MEMORANDUM

SUBJECT: Peer Review: West End at Beachwalker (Parcel ID: 207-05-00-117; 207-05-00-116)
Application for Multifamily Residential Development

West End at Beachwalker (Source: Site Development of the West End at Beachwalker, Sheet EC3.1)

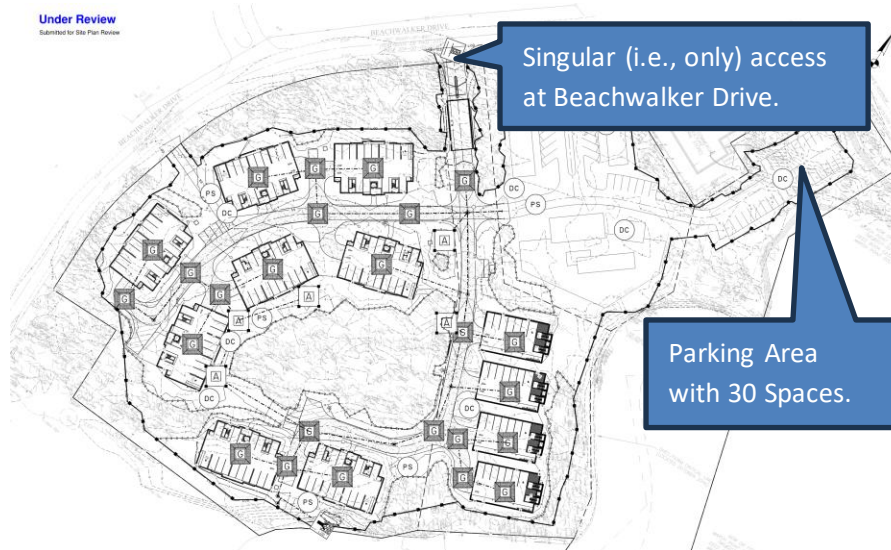
Stabilized construction entrances are to be located at all points of ingress/egress to the construction site. There are two stabilized construction entrances proposed along Beachwalker Drive on the northeast portion of the project site, while there appears to be a potential third point of access located further to the west for proposed utility work. It is recommended that the applicant confirm that no ingress/egress to the construction site will be provided at this third location and that controls will be put in place during construction to ensure this location will not be used for site access.
